X-treme Hydro Line Routing

Part # 533113 @ 6 O'clock positions

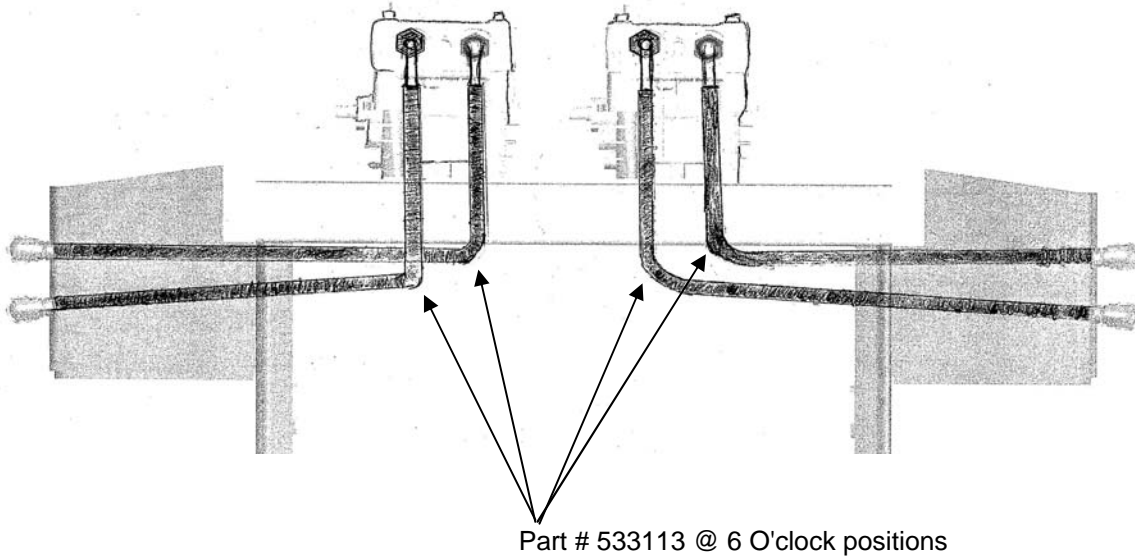
Details: Rotate hydro pump lines to a 6 o'clock position. By rotating the lines to a 6 o'clock position, it will help prevent lines from being interfered with by the deck. When performing this adjustment, the wheelmotor fittings may have to be rotated to a 3 o'clock position so as to accommodate the repositioning of the hydro lines.
